**Pebble Mine Geohazard and Tailings Dam Embankments Analyses of
Dr. T. O'Rourke and Dr. Izzat M. Idriss**

(Submitted Summer 2019 During DEIS Public Comment Period)

TO: Bristol Bay Reserve Association
FROM: Tom O'Rourke
RE: Geohazards Affecting the Pebble Mine Complex

Subject: *Review of Selected Portions of the Draft Environmental Impact Statement (DEIS) for the Pebble Mine Complex Related to the Tailings Dam Embankments*

Figure reproduced from the DEIS.

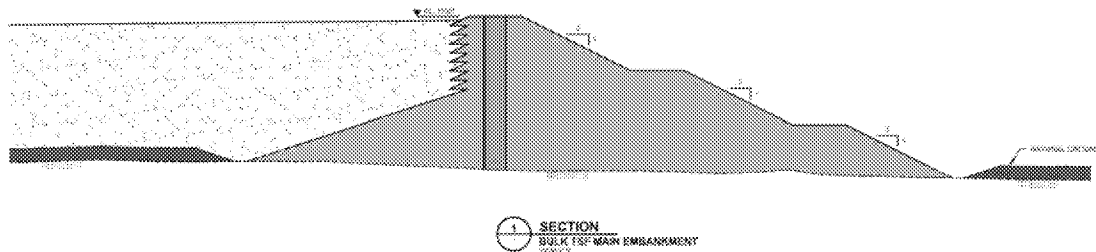
The embankments cross sections I found in the portions of the DEIS I reviewed are more of a "cartoon" rather than a useful engineering cross section that depicts the various zones of the embankment (core, shell, filter and drainage layers) and underlying foundation layers (soil layers, rock). The maximum section of the bulk tailings storage facility (TSF) is included in the DEIS and is shown below to illustrate the inadequacy/incompleteness of the information provided for review.

Far more details are required, including extent (depth and width) and material properties, for each embankment zone and for each foundation soil layer. In addition, the key properties of the underlying rock units need to be provided and analyzed in the DEIS.

The "Christmas-tree" upstream zone of the section of the bulk TSF embankment, shown in the figure above, requires unique details to be successful, such as: (i) adequate beach; (ii) upstream filters; (iii) minimum width and compaction of the upstream shell and of the filters; (iv) minimum width of core; and (v) appropriate geochemical/geotechnical characteristics of the core materials; etc. None of these details are included in the DEIS.
